CERTIFICATE OF APPROPRIATENESS

Property: Residence B, Block 2, Norhill Neighborhood Subdivision. The property includes a historic 5,390 sq. ft., one-story painted brick commercial building, situated on a 19,998 sq. ft. (100' x 200') corner lot.

- Sign Starbucks logo, 5 ft. diameter, illuminated, mounted South façade over entrance door.
- Sign "Starbucks", illuminated, mounted East façade.
- Sign "Starbucks", illuminated, mounted on knee wall planter South face.
- Install new windows and front door in existing openings
- New outdoor patio and knee wall 19' x 14'-2'-6", patio furniture, new pergola system 6"x6" wood with metal hardware, 8'-6 1/2" height, at outdoor seating, new planters and wall lighting scones. All other exterior facade/finishes to remain as existing
- Set of (2) wall sconces flanking entrance door, with exterior conduit wall mounted.
- Existing Building mural to remain intact.

EXTERIOR PERSPECTIVE 11TH & NORHILL

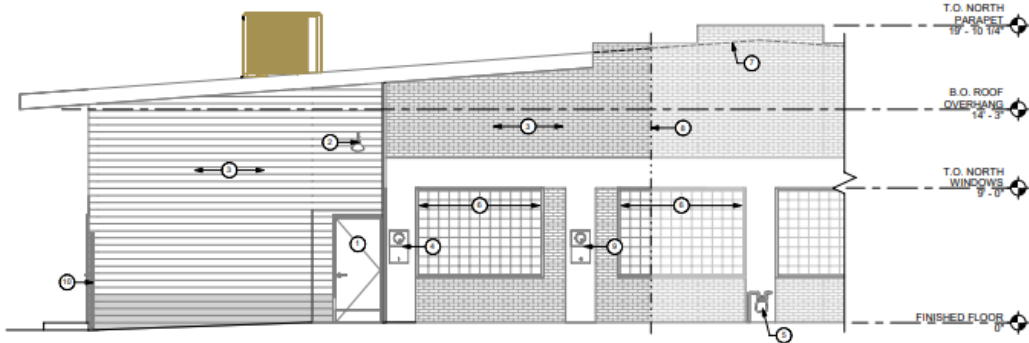
Use a different spec than conventional building sign channel letters. And reduce size a little.
